**LOUISIANA**  
**POWER & LIGHT**

March 3, 1983

SUBJECT: Waterford SES 3  
Docket No. 50-382  
ECCS Reanalysis

Please find enclosed a submittal of a draft amendment to the Waterford 3 FSAR. This draft amendment consists of the results of a revised large break LOCA ECCS performance analysis and updates FSAR Section 6.2.1.5 (minimum containment pressure analysis), Section 6.3.3.1 (introduction and summary), and section 15.6.3.3.1 (large break LOCA). In addition, several references are added to Section 15.6 defining the ECCS performance model revision used in this analysis to conform with the required clad deformation and flow blockage model guidelines of NUREG-0630. This information will be included in our next FSAR Amendment.

FIGURE 6.2-30B

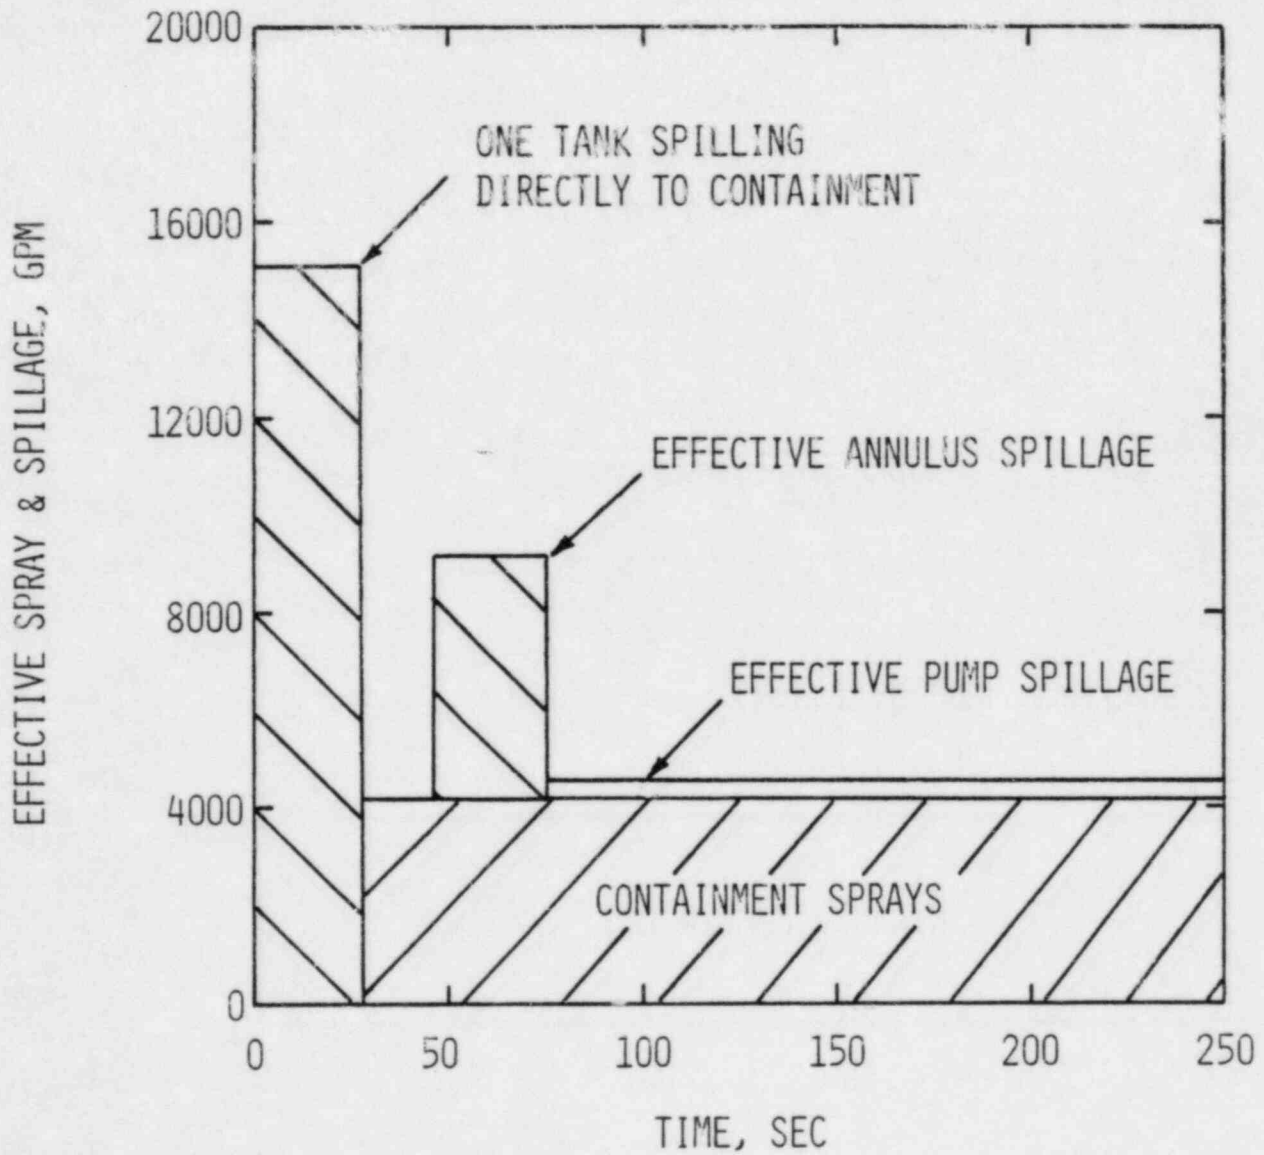
The effect of mixing and condensation of containment steam with spilled ECCS water upon the containment pressure is calculated in the manner described in Section III.D.2 of Reference 12. The effective ECCS spillage rate is shown as a function of time in Figure 6.2-30b.

FIGURE 6.2-31A  
WATERFORD 3  
0.8 x DE GUILLLOTINE BREAK IN PUMP DISCHARGE LEG  
MINIMUM CONTAINMENT PRESSURE

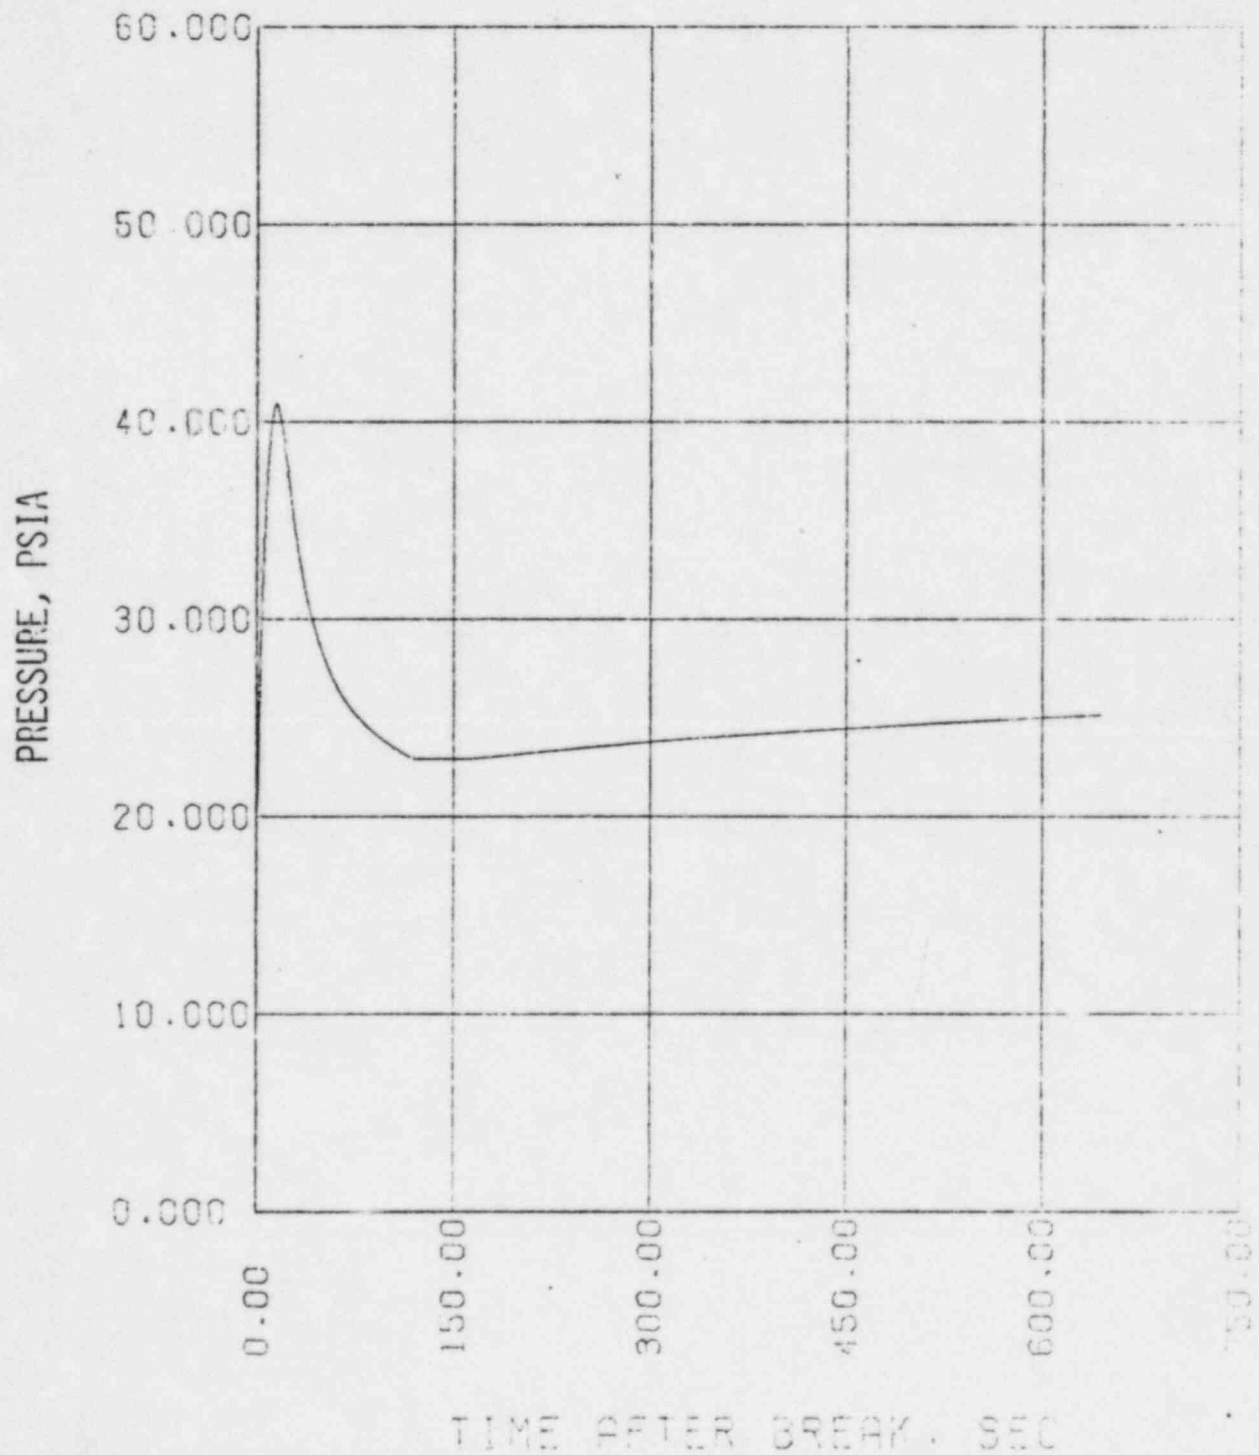
For the most severe LOCA, the 0.8xDEG/PD break, the minimum containment pressure response is shown in Figure 6.2-31a. As required by 10CFR50 Appendix K, the containment pressure used in the ECCS performance evaluation does not exceed this pressure (see Figure 15.6-107). The responses of the containment atmosphere and SIS (recirculation) sump temperatures are shown in Figures 6.2-31b and 6.2-31c, respectively. The containment pressure responses for breaks other than the worst break are presented in the figures in Subsection 15.6.3.3.

FIGURE 15.6-128  
PEAK CLAD TEMPERATURE vs. BREAK AREA

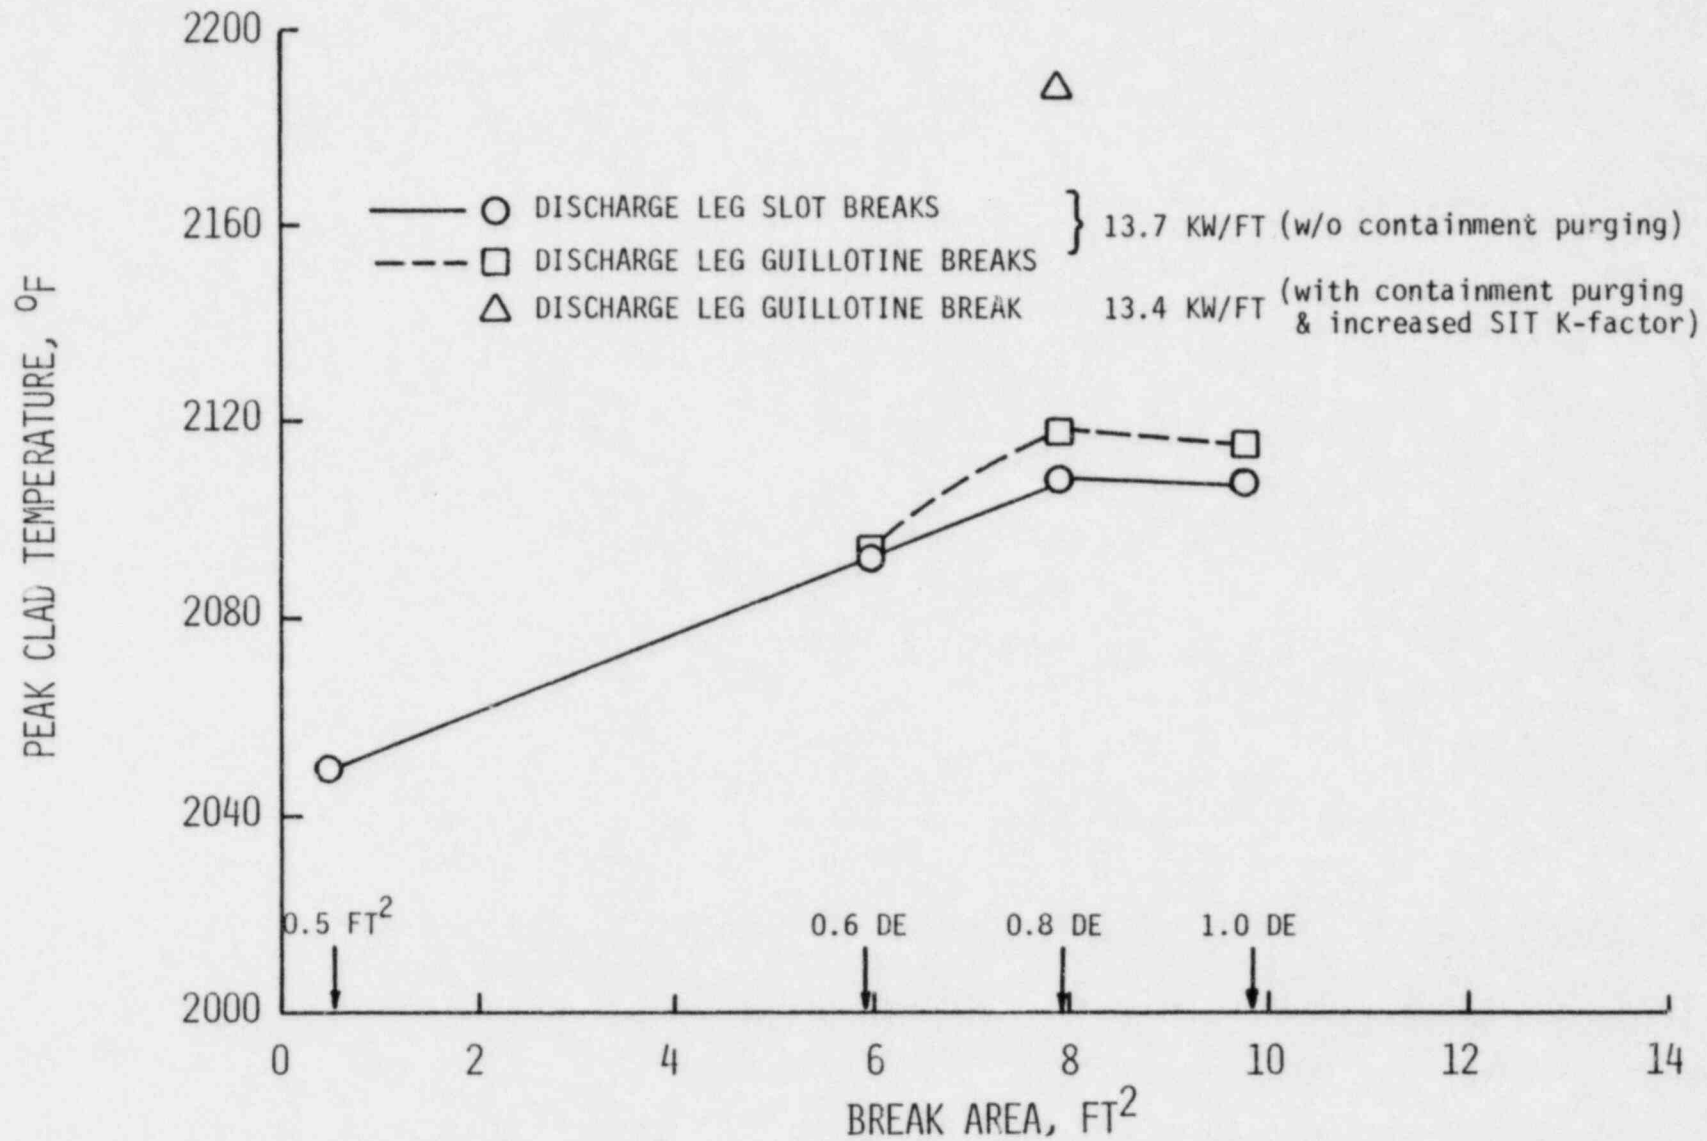
Break, Size, Type and Location	Abbreviation	Figure	
1.0 x double-ended slot break in pump discharge leg	1.0 x DES/PD	15.6-36 through 15.6-44	
0.8 x double-ended slot break in pump discharge leg	0.8 x DES/PD	15.6-45 through 15.6-53	
0.6 x double-ended slot break in pump discharge leg	0.6 x DES/PD	15.6-54 through 15.6-62	23
0.5 ft <sup>2</sup> slot break in pump discharge leg	0.5 ft <sup>2</sup> S/PD	15.6-83 through 15.6-91	
1.0 x double-ended guillotine break in pump discharge leg	1.0 x DEG/PD	15.6-92 through 15.6-100	
0.8 x double-ended guillotine break in pump discharge leg	0.8 x DEG/PD	15.6-101 through 15.6-109k	23
0.6 x double-ended guillotine break in pump discharge leg	0.6 x DEG/PD	15.6-110 through 15.6-118	23
Peak clad temperature vs. break area		15.6-128
